Pacific Grove Unified School District
435 Hillcrest Avenue, Pacific Grove, CA 93950
Robert Down Elementary School Site Improvements
Notice to Bidders - Addendum 03

Addendum Date: 3/23/2026

AD03-01: Revisions to Project Manual

AD03-02: Pre-Bid Questions and Answers

SHEET #
AD3-C3.2

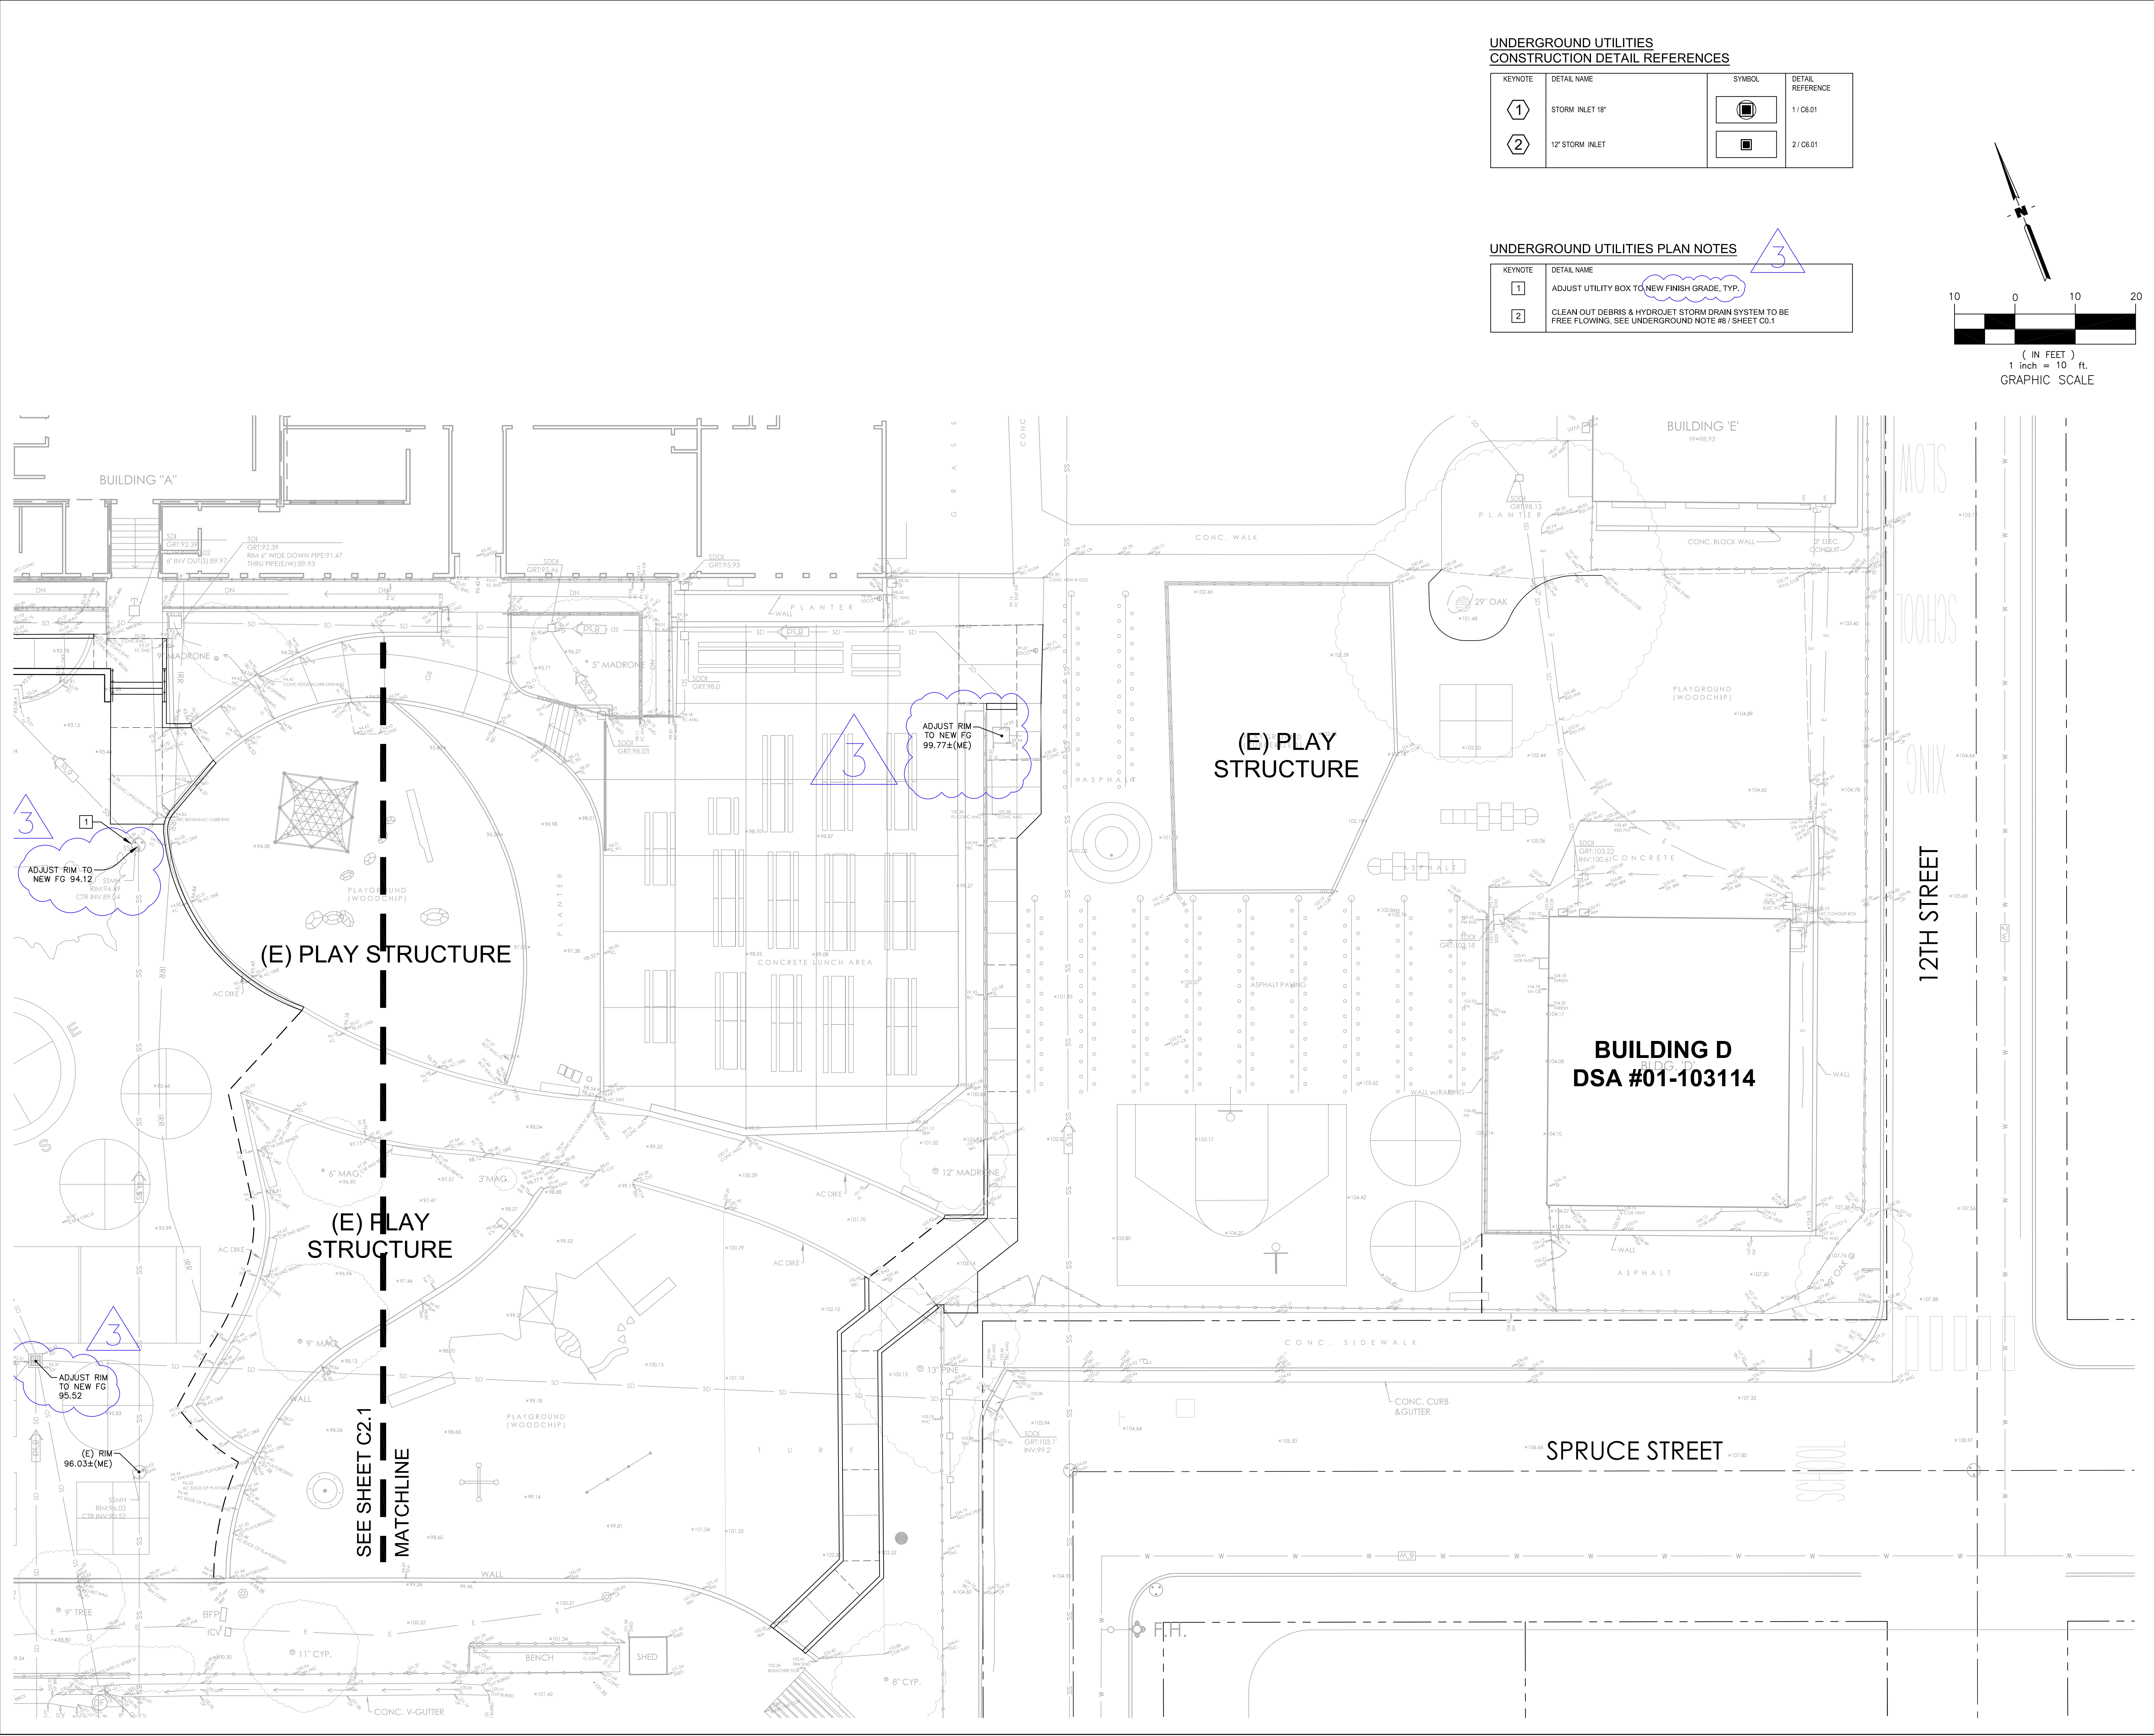
ITEM 3D.015 C3.1 & C3.2 – UNDERGROUND UTILITIES PLAN
Revise: Existing Drain Inlet Rim elevation revised nearby existing Play Structure.
Revise: Existing Drain Inlet invert grade revised.
Revise: Existing SSCO relocated out of Valley Gutter.

5 CONCRETE CURB - TYPE V SCALE: NTS

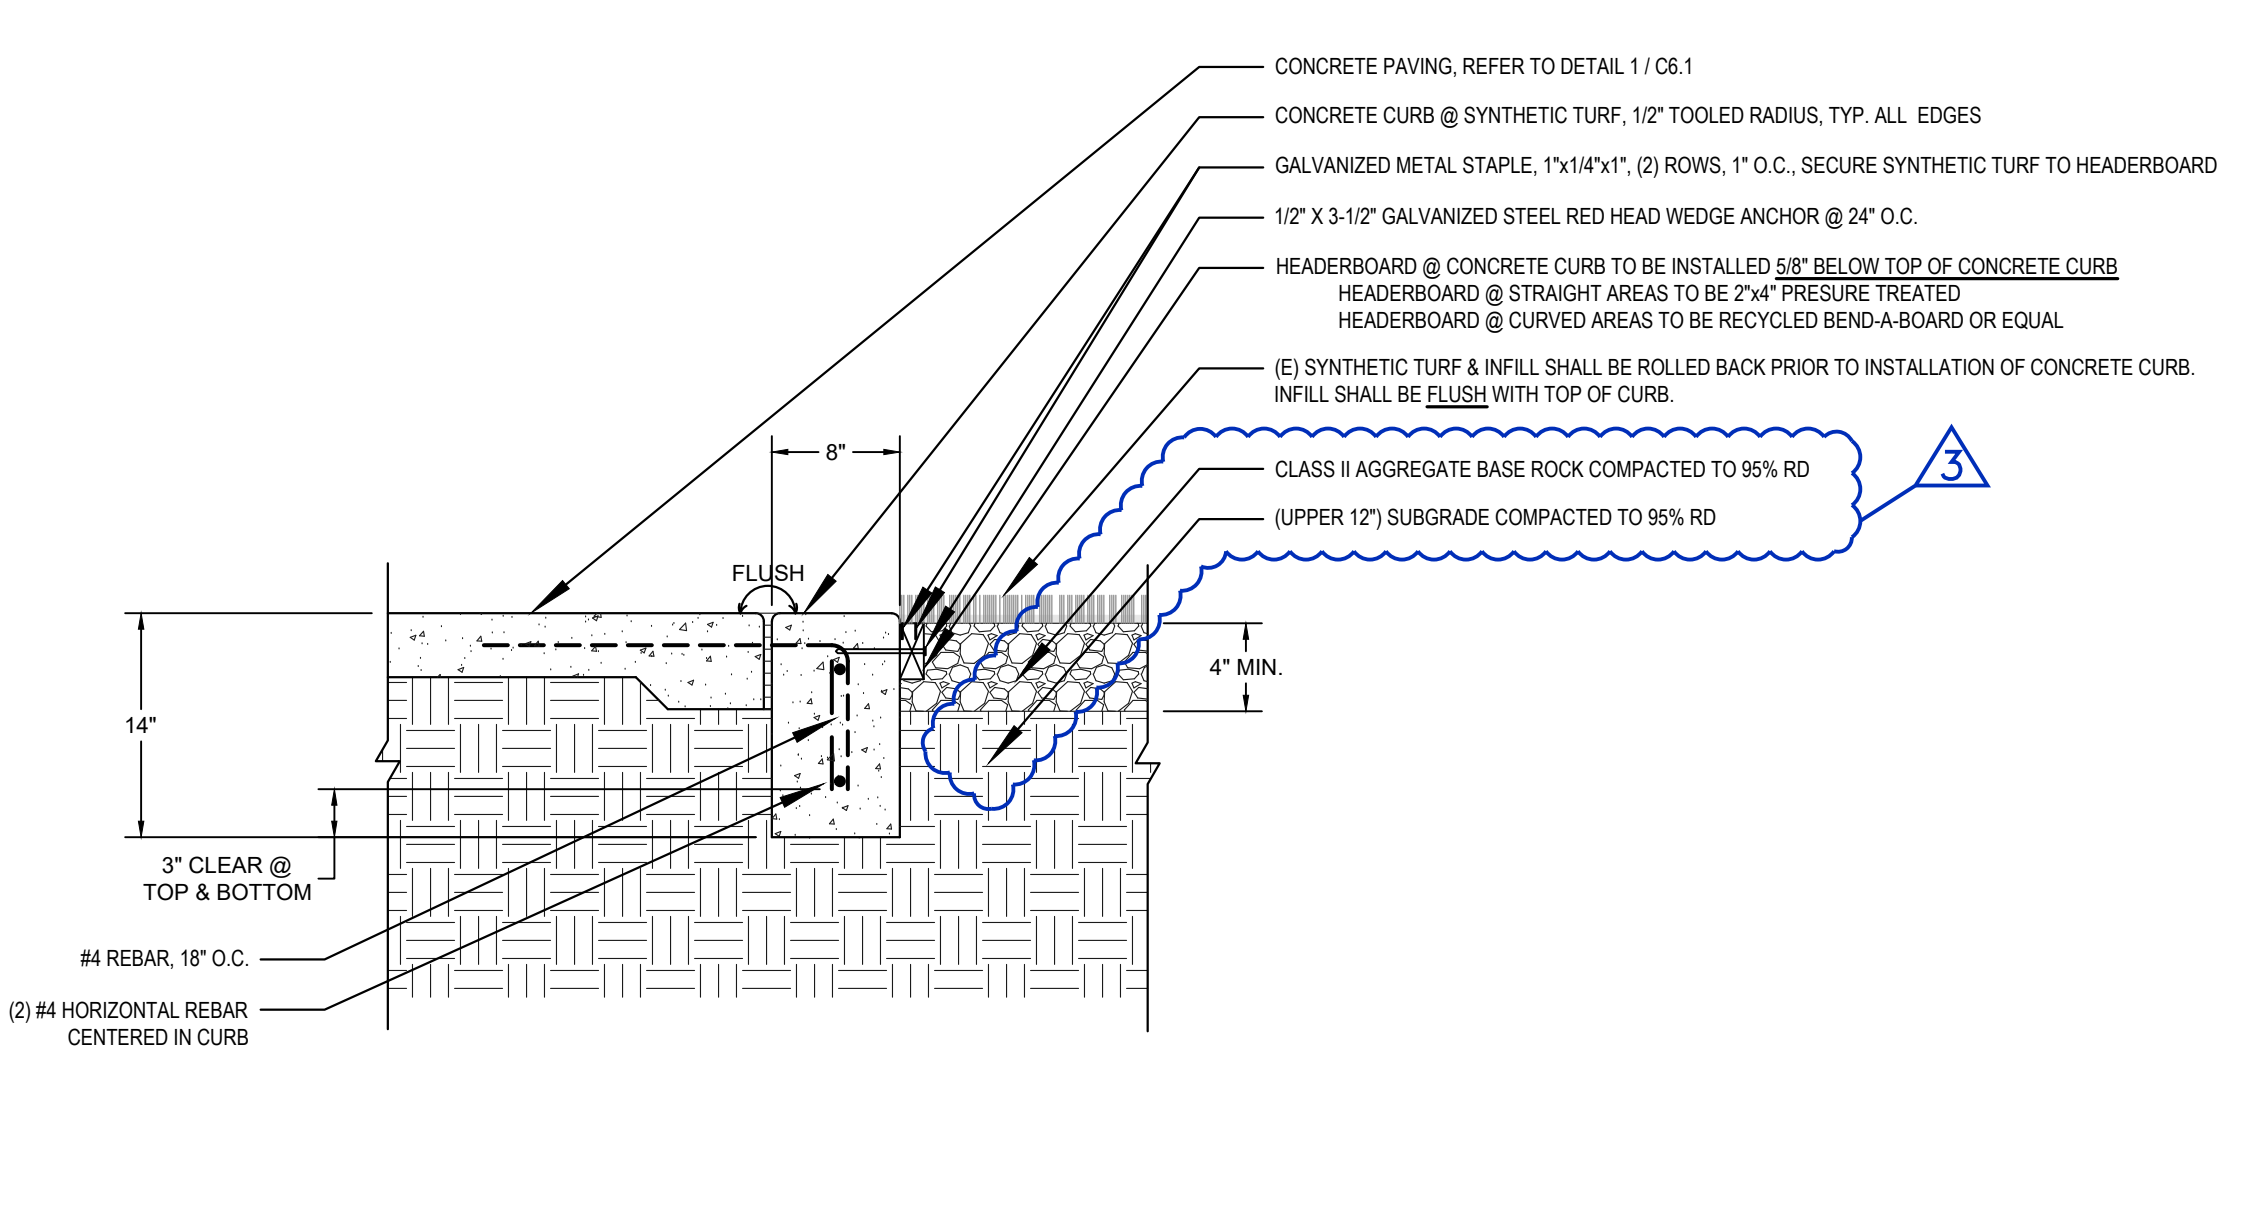
9. Please provide detail Referenced for P7 - 7/C6.1 - roll back artificial turf area as described on C7.2.
The artificial turf re-installation should be completed per detail 5/C6.2. This is corrected in Addendum 3.

ITEM 3D.017 C6.2 – Construction Details
Detail 5 – Concrete Curb – Type V
Change: Class II Aggregate Base Rock Symbol from existing to new.
Add: Class Aggregate Base Rock Compacted to 95% RD callout to detail.
Add: (Upper 12”) Subgrade Compacted to 95% RD callout to detail.

PROJECT #
 DCA 25.054
 CEI 3263
 ISSUE DATE:
 12/22/2026
 SHEET #
C7.2

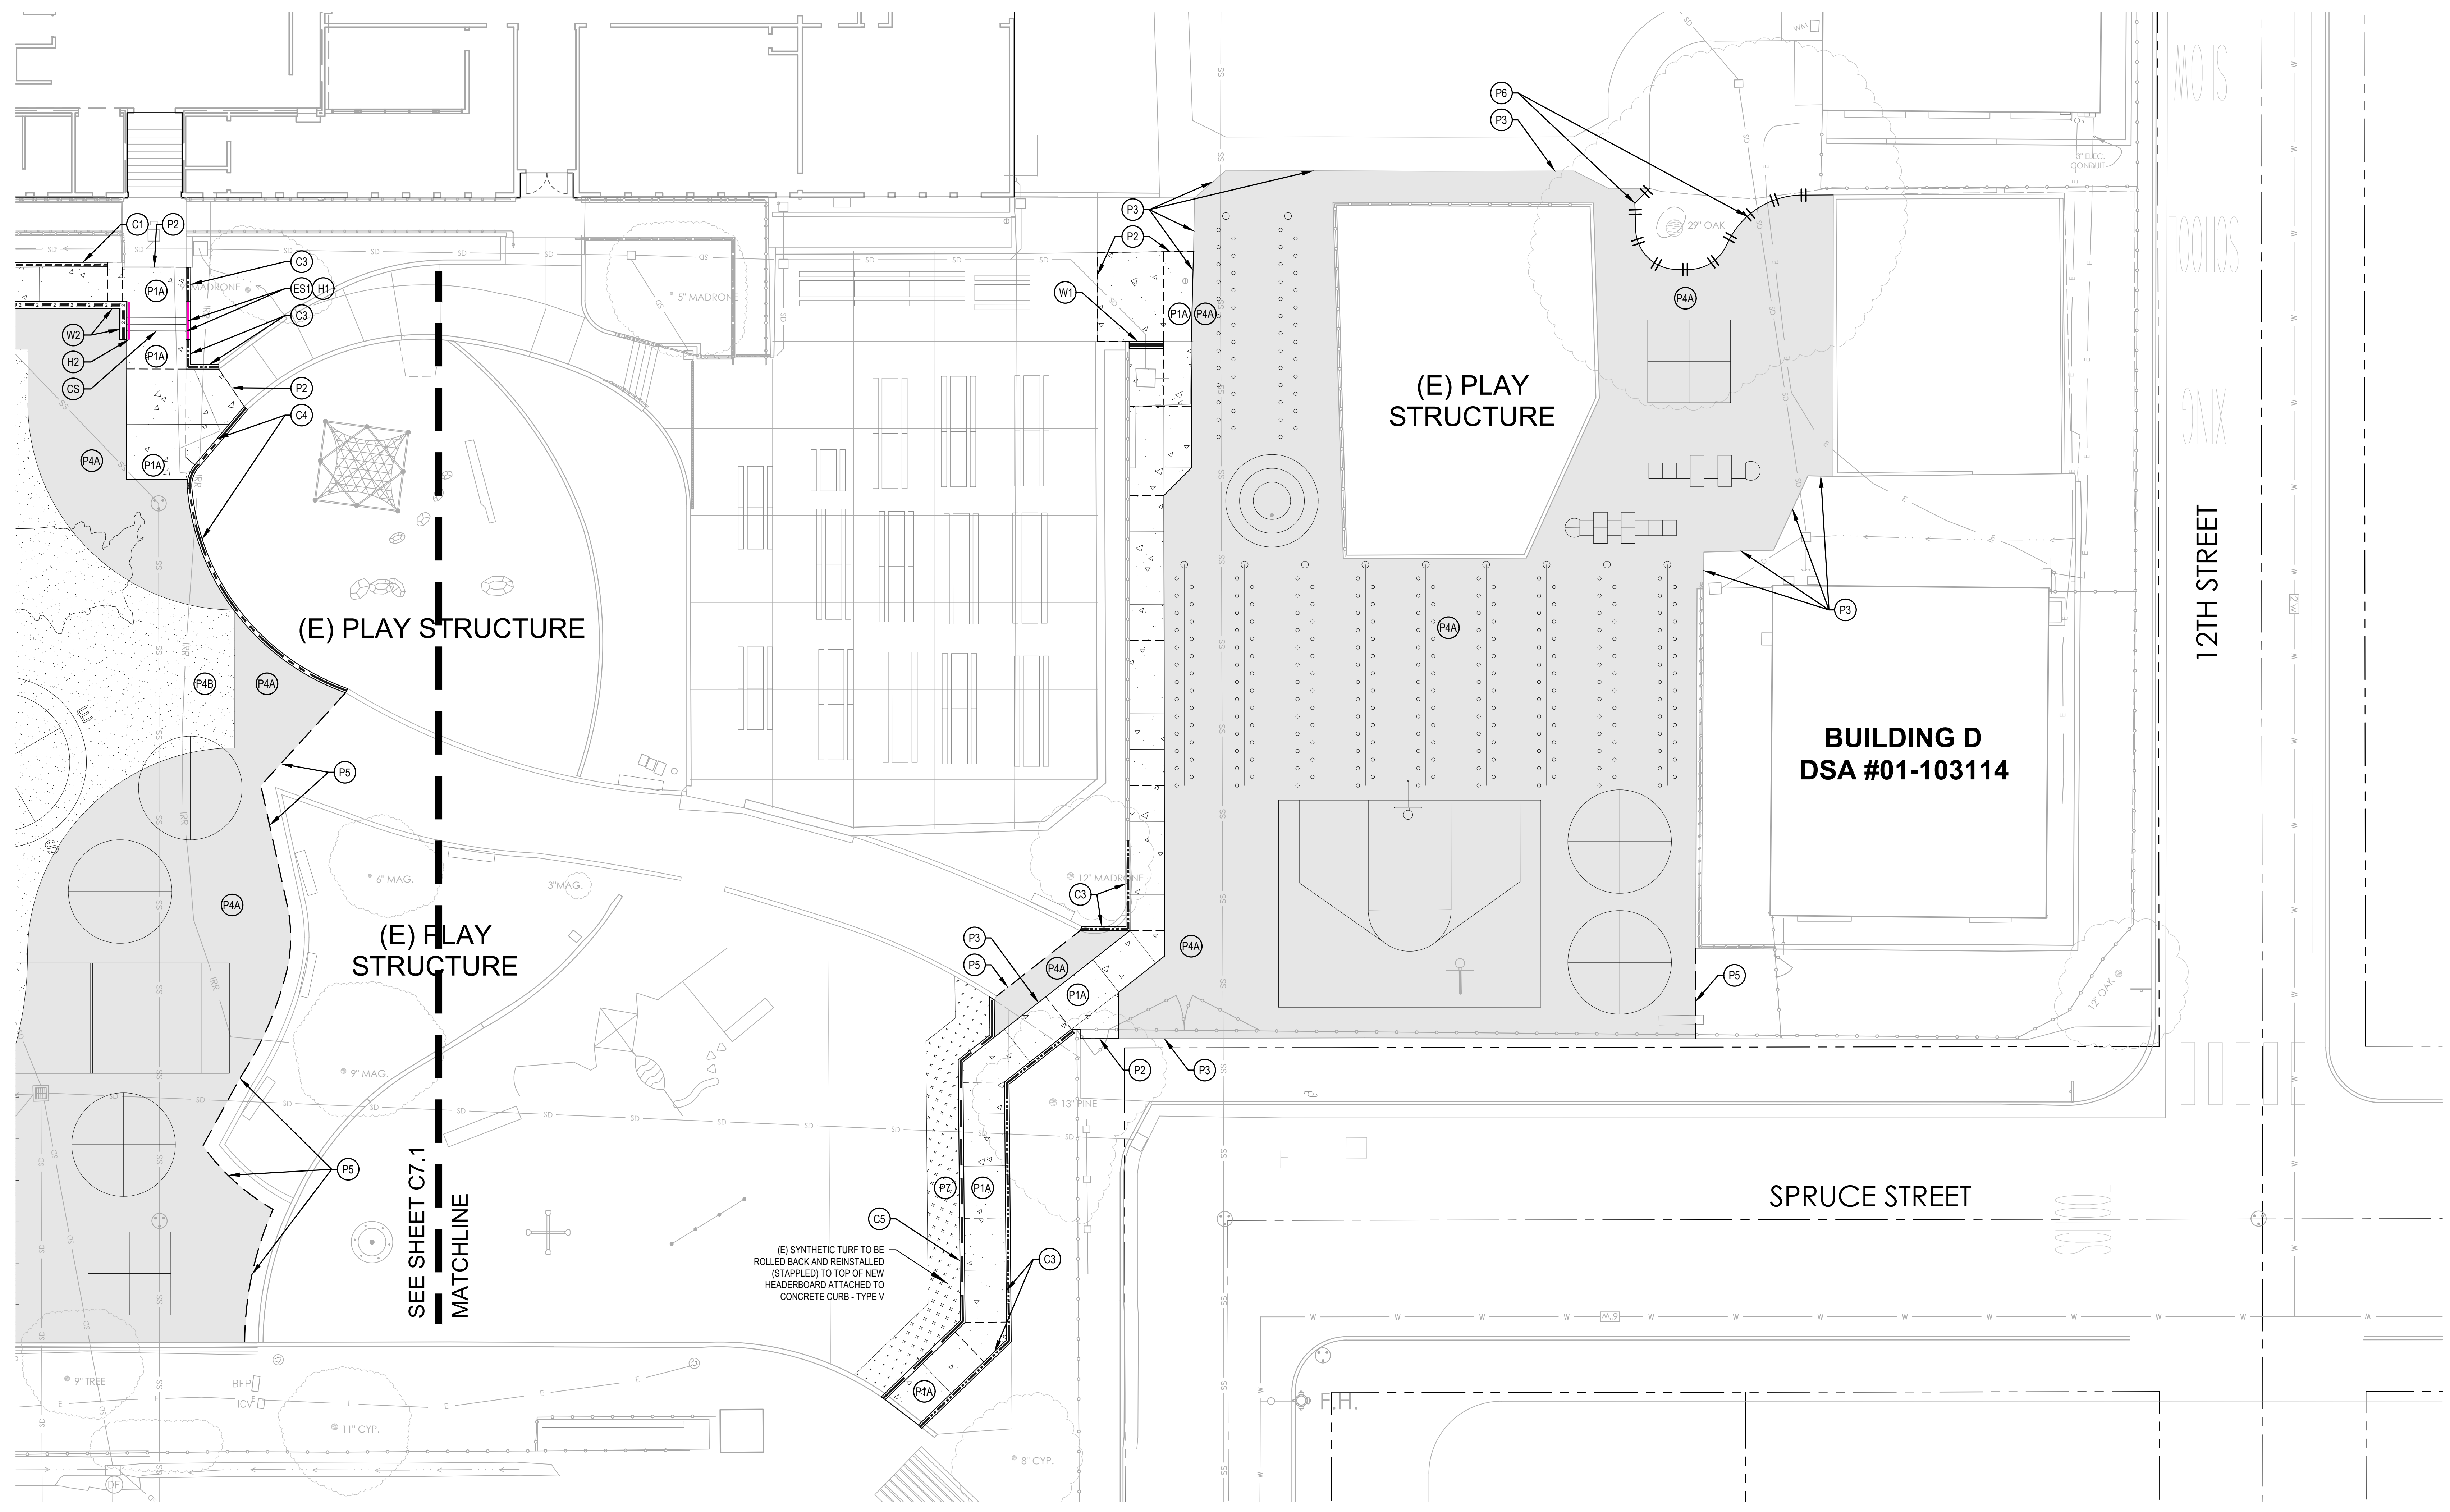
ITEM 3D.018 C7.2 – MATERIAL & DETAIL REFERENCE PLAN
Revise: P7 - (E) synthetic turf to be rolled back and reinstalled Detail Reference in the Material & Detail Reference Legend to read as 5/C6.2.
